**SUBJECT:** Service Manual Correction

MODEL: CRO Europe and Asia  
Version

This information includes corrections to the CRO service manual.

## Technical Bulletin

### 1. Section 3.2.4. (Page 3-6)

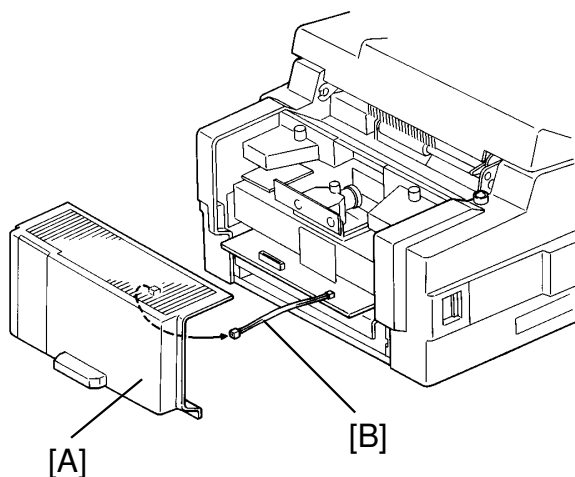
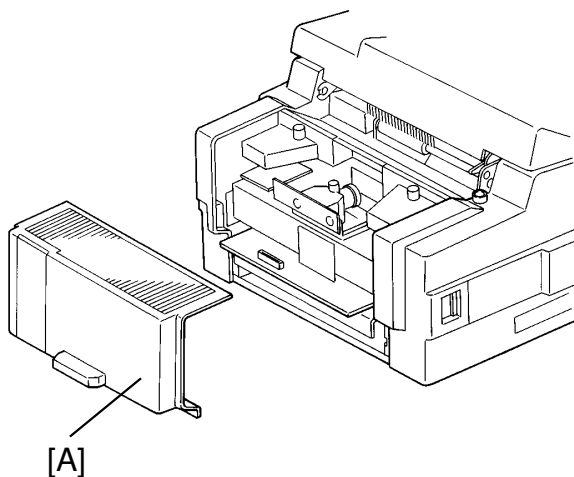
The item 4 has been changed, because the CRO does not have the monitor speaker.

4. Take off the rear cover [A] and  
disconnect the monitor speaker [B].

4. Take off the rear cover [A].

### [Problem]

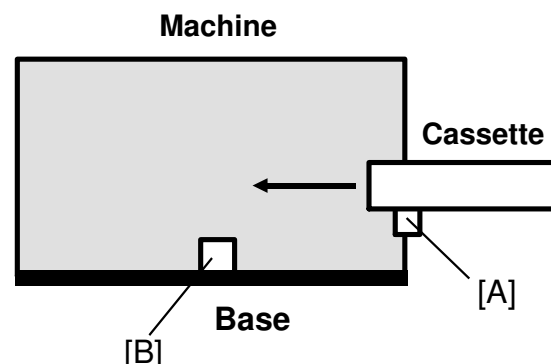
The bottom plate of the A4 (letter) size standard cassette is not lifted up even if the cassette is inserted into the machine.

When installing the cassette, the slider [A] should contact the Boss [B] on the base.

However [A] does not contact [B], because of the warp of the cassette and the base plate of the machine.

Temporary: Insert a washer (t=0.5mm, P/N: 07010030B) between the Boss [B] and the Base plate of the machine

Permanent: The height of the Boss [B] (P/N: H0813561) has been changed from 6mm to 7mm.

- Install a plastic cap (which packed with this RTB) onto the Boss.  
Use a glue for plastic.  
or
- Insert a washer(P/N: 07010030B) or an M4 E-ring (P/N: 07200040E) between the Boss and the Base Plate.

To improve image quality, the OBM (master unit) has been modified, as shown below.

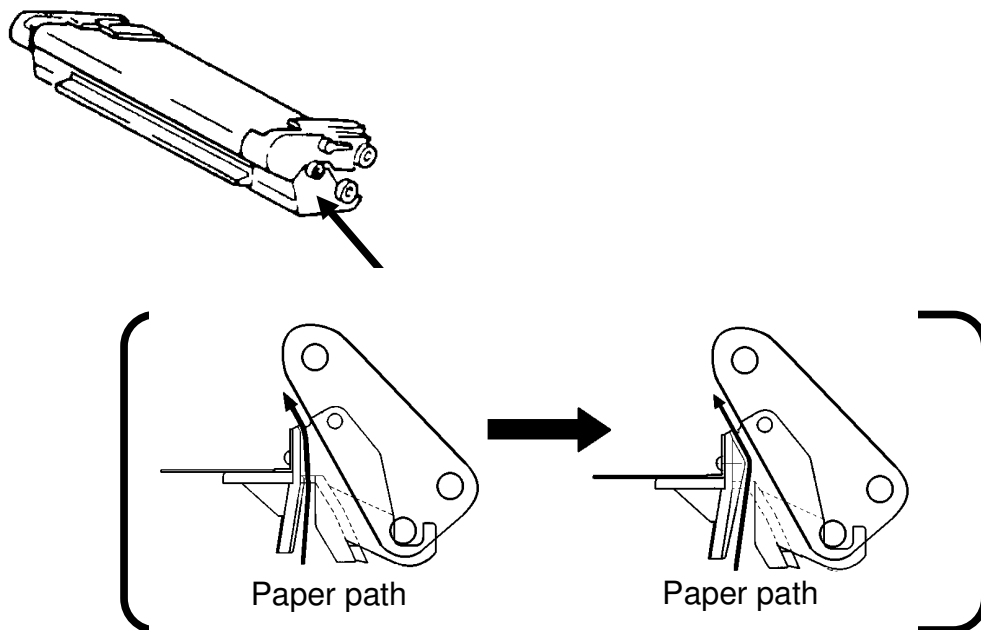
When the paper passes over the master belt, toner sometimes does not transfer to the paper properly.

Therefore, the paper path inside the master has been changed, and the paper makes better contact with the master.

This has been executed from October production.

### [Cause]

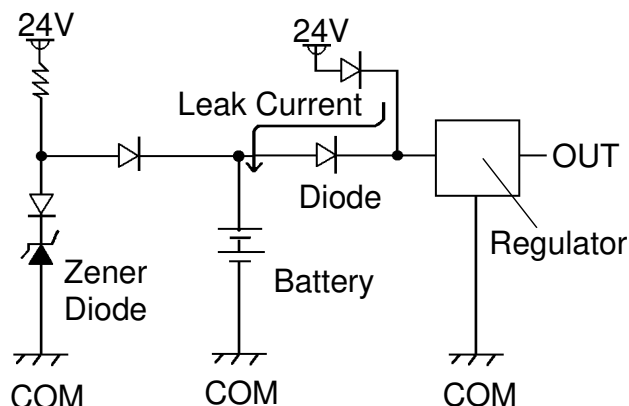
Power loss from the memory back-up battery on FCU caused by excessive charge current, for the following reasons.

(1) Leak current from Diode

The battery is charged after it is already fully charged. This type of battery is damaged if this occurs.

- (2) Excessive charge voltage (CFO, CS1, LHO) The target charge voltage was 6.2V against 6.4V or under which is recommended by the battery maker. This margin was too small for this battery.

See MB C Series-048A.

**Inside of FX6 and LSO**

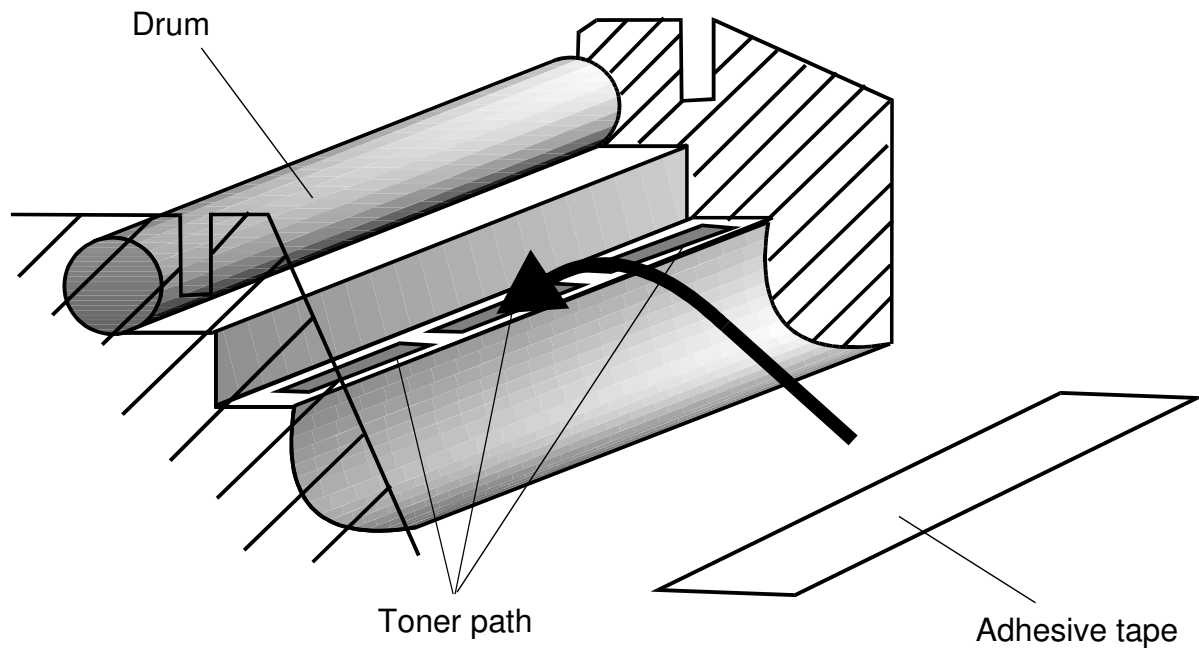
However, the toner path under the CTM must be covered by some adhesive tape. See the attached illustration.

Note: Adhesion of the tape should not be strong. Otherwise, it may not be taken off cleanly from the machine, or the toner path may be damaged when it is taken off.

## Harness Check Procedure

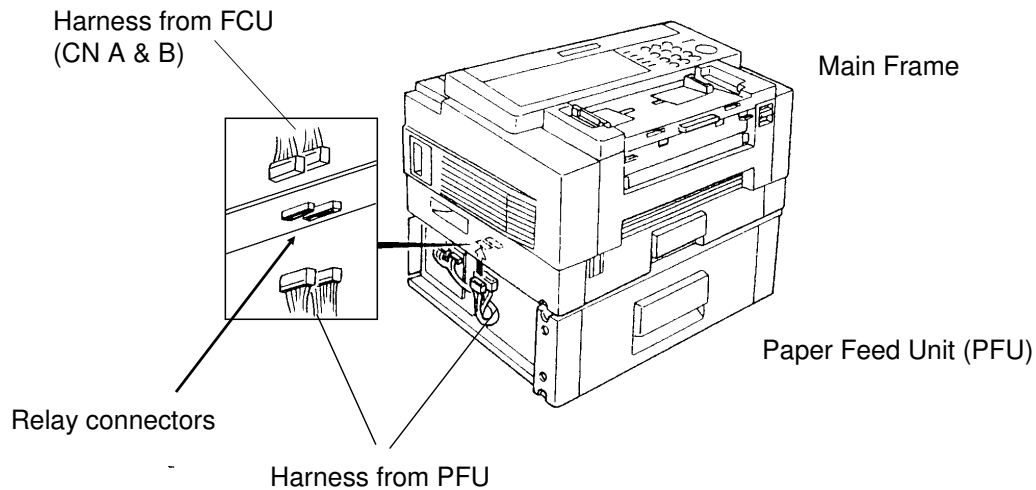
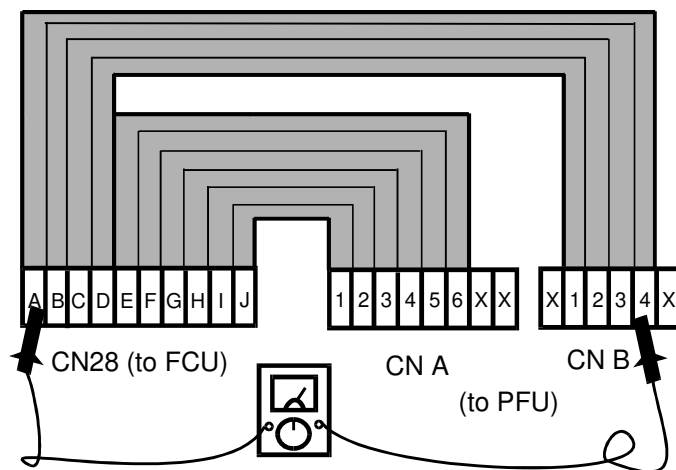
**Cause:** Wires of the harness (H511 5528) from the FCU to the relay connectors for the paper feed unit (PFU) are not allocated properly.

1. Remove the Rear Cover and Left Cover.
2. Unplug the connector CN28 on the FCU.
3. Unplug the connectors CN A and CN B on the relay connector board located at the bottom of Main Frame.

4. Check the continuity of the harness pin by pin using a multimeter.  
See below for what the correct allocation of all wires of the harness should be.

A of CN28	to	4 of CN B	E of CN28	to	6 of CN A
↓		↓	↓		↓
D of CN28	to	1 of CN B	J of CN28	to	1 of CN A

## Hot Roller Kit:

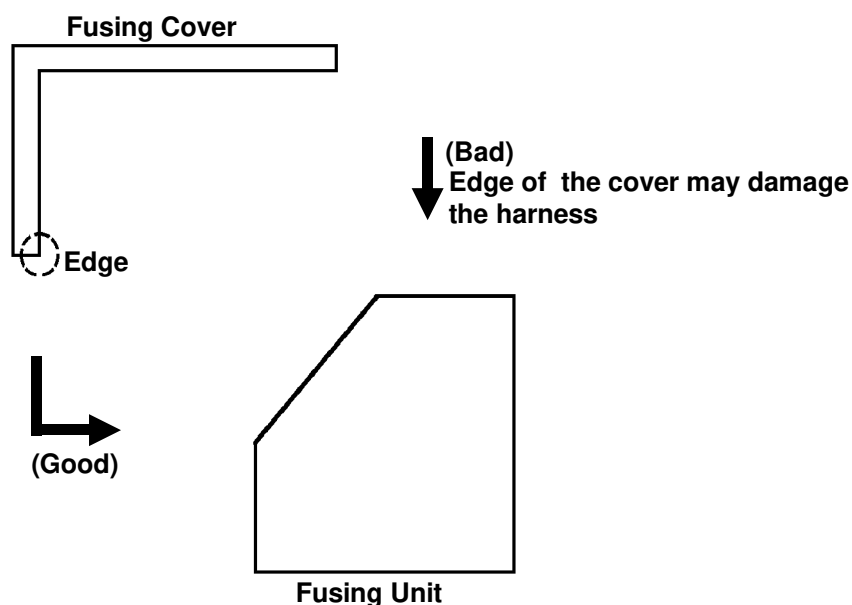
The hot rollers shipped from the SPC in Japan will be replaced by the Hot Roller Kit in July.

This kit will be comprised of the following: Hot Roller, Cleaning Pad, Thermistor, Thermistor Bracket, Screw, Strippers (2), Stripper Springs (2) and Installation Sheet. The individual Hot Roller will be no longer available. The Cleaning Pad will continue to be a Service Part.

Ricoh recommends change of the above modified parts and Cleaning Pad when the failed Hot Roller is replaced with the new one.

## Installation Procedure for the Thermistor

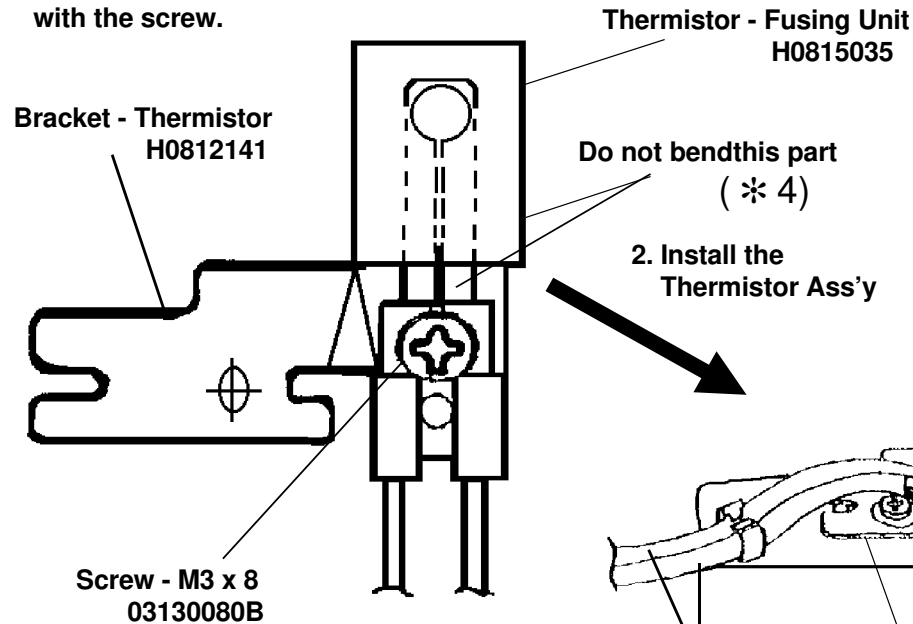
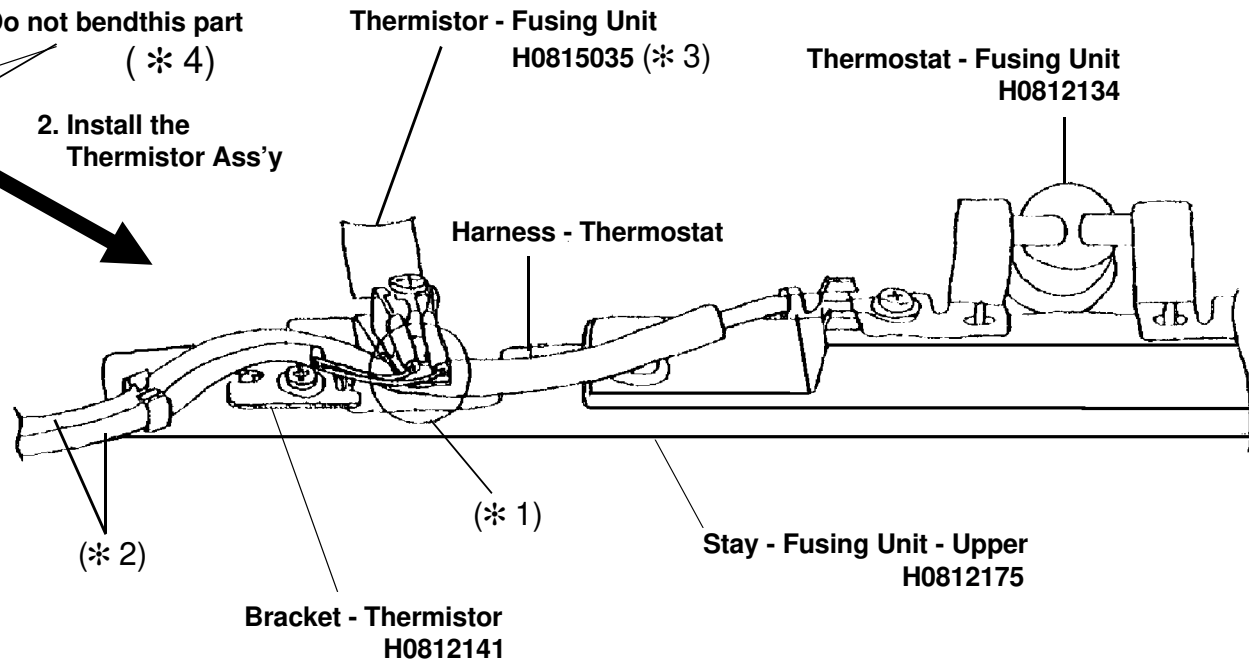
**(A): Please refer to the following instructions and fix the cover to the fusing unit and check that the harness is not pinched before installing the fusing unit in the machine.**

**If the metal wire of the harness contacts the thermistor bracket, a no power condition may occur. Please check the thermistor harness if this occurs.**

1. Assemble the thermistor and the bracket with the screw.

2. Install the Thermistor Ass'y

- Note: \* 1 Place the thermostat harness under the part of the bracket.
- \* 2 Do not cross the thermostat harness and the thermistor harness.
- \* 3 Push the thermistor head (sensor) gently against the hot roller with a finger to make sure that the thermistor head touches the hot roller surface. Do not push it strongly.
- \* 4 Do not bend the thermistor neck (spring plate) when installing or cleaning it .  
If the thermistor is bent, replace it.
